SAN FRANCISCO PLANNING DEPARTMENT

Certificate of Appropriateness Case Report

Filing Date: July 28, 2015
Case No.: 2015-009585COA
Project Address: 1668 BUSH STREET
Historic Landmark: Landmark #65: Trinity Episcopal Church
Zoning: RM-4 (Residential – Mixed, High Density) District
80-A Height and Bulk District
Block/Lot: 0665 / 015
Applicant: Naomi Miroglio
Architectural Resources Group
Pier 9, The Embarcadero
San Francisco, CA 94111
Staff Contact Eiliesh Tuffy - (415) 575-9191
eiliesh.tuffy@sfgov.org
Reviewed By Tim Frye – (415) 575-6822
tim.frye@sfgov.org

Narthex, North Wall:
location of proposed new shear wall construction (Sheet A4.2)

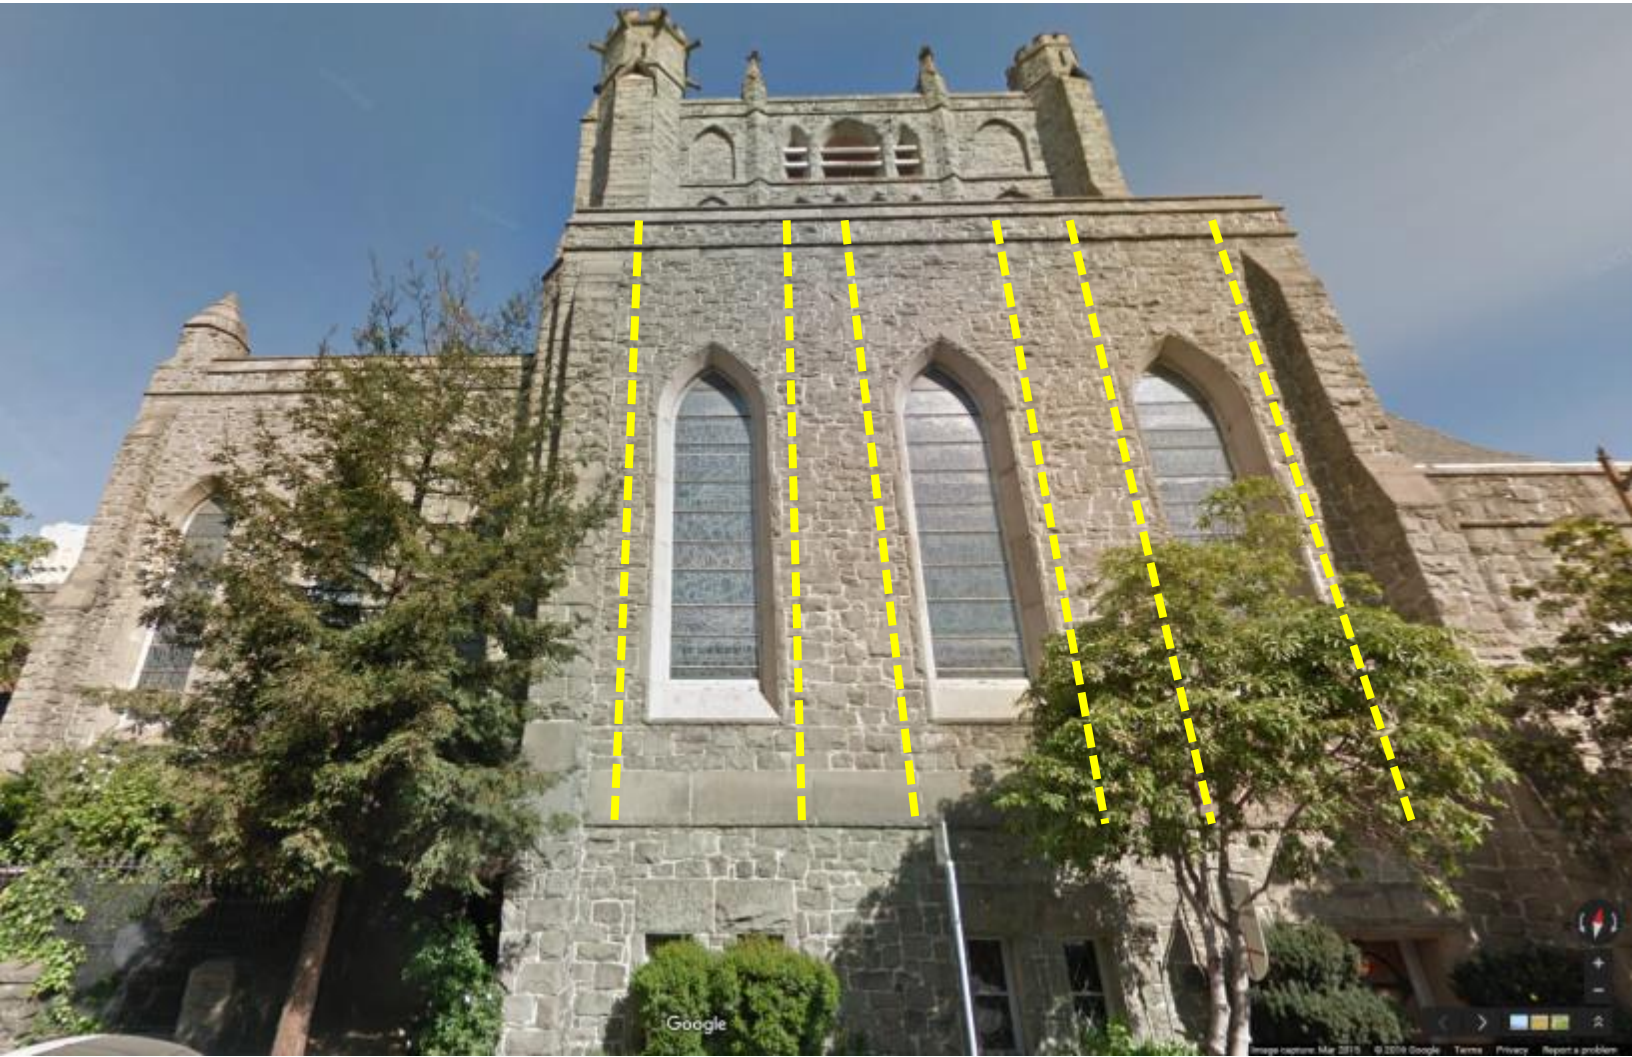
The north wall of the narthex, which contains a set of wood double doors that exit out to the courtyard, is proposed for seismic strengthening. The new concrete shear wall is proposed to be installed along the outer edge of the arched opening. A new single, custom wood door in a simplified version of the historic design is proposed to replace the existing double doors. The new infill material within the reduced rough opening would be approximately 15 inches wide and would retain the angled profile of the historic sandstone door surround. The infill material, which would be visible from the courtyard – and to a lesser degree from Gough Street – would be plaster finished in a texture reminiscent of the historic sandstone finish. This approach is the project sponsor's preferred design option.

An alternate approach to the seismic strengthening of the narthex north wall is a continuous shear wall spanning the entire historic rough opening. In the alternate design, the existing wood double doors would be salvaged and reinstalled on the exterior-facing surface of the new concrete shear wall. As currently designed, the alternate shear wall infill material would be 9 inches wide and would be in-plane with the reattached doors. The operational hardware would be removed to meet fire code requirements and new signage would be required to clearly identify the doors as non-operational.

By contrast, the alternate design proposal for the narthex north shear wall would retain the historic doors, just in a different plane, lessening the noticeable difference in their relationship to the historic opening. What infill material is required around the reinstalled doors would help identify that an alteration had occurred, but through a more subtle design. The placement of a continuous shear wall within the historic rough opening would render the north entrance non-functional but would not impede access to the narthex from the other three functioning doors on the west wall. Based on this analysis, staff recommends the following Conditions of Approval:

1. The sponsor shall pursue the alternate design for the narthex shear wall that reuses the historic double doors (Sheet A4.2, drawing 6.5) to minimize the appearance of alteration to an original design feature with high public visibility.
2. The project architect and engineer shall work with staff to determine if a shear wall placed either entirely or partially on the interior narthex's north wall is possible to minimize exterior alterations to the historic rough opening, retain as much of the exterior sandstone reveal as feasible in order to avoid obstructing historic building fabric in this location.

Transcept and Altar Access Ramp

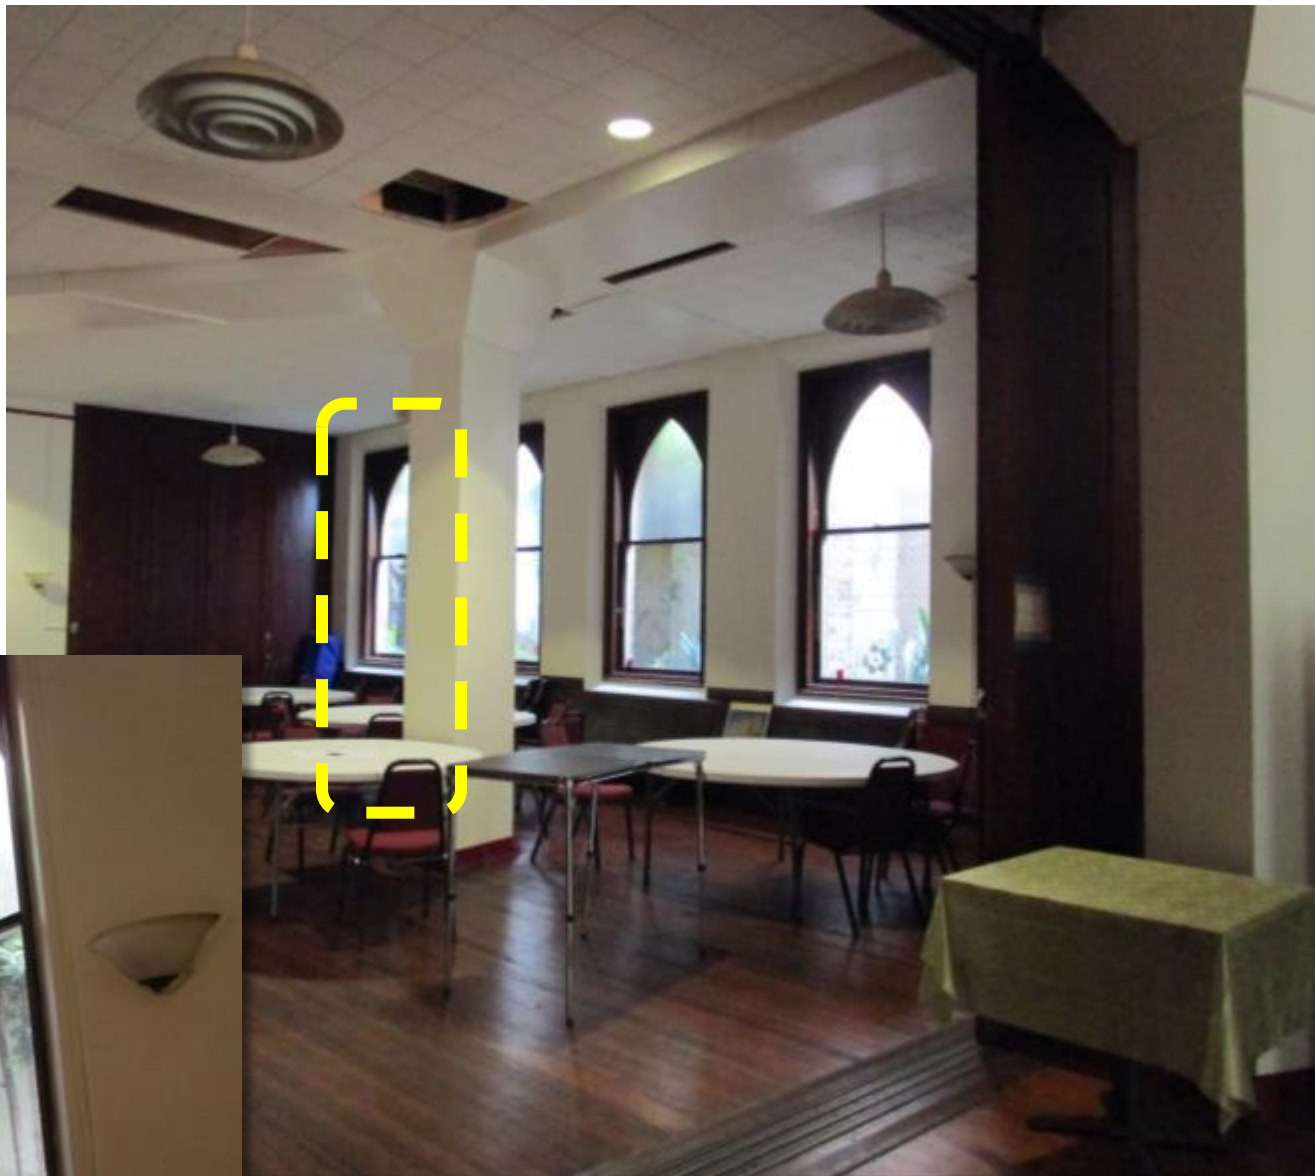
Installation of a new ramp with a forged steel handrail is proposed at the southeast corner of the sanctuary interior to provide access to the main altar through the transept corridor. The ramp has been designed to rest on top of the historic tile floor and marble stairs, rather than have mechanical attachments, to prevent damage to the historic building fabric.
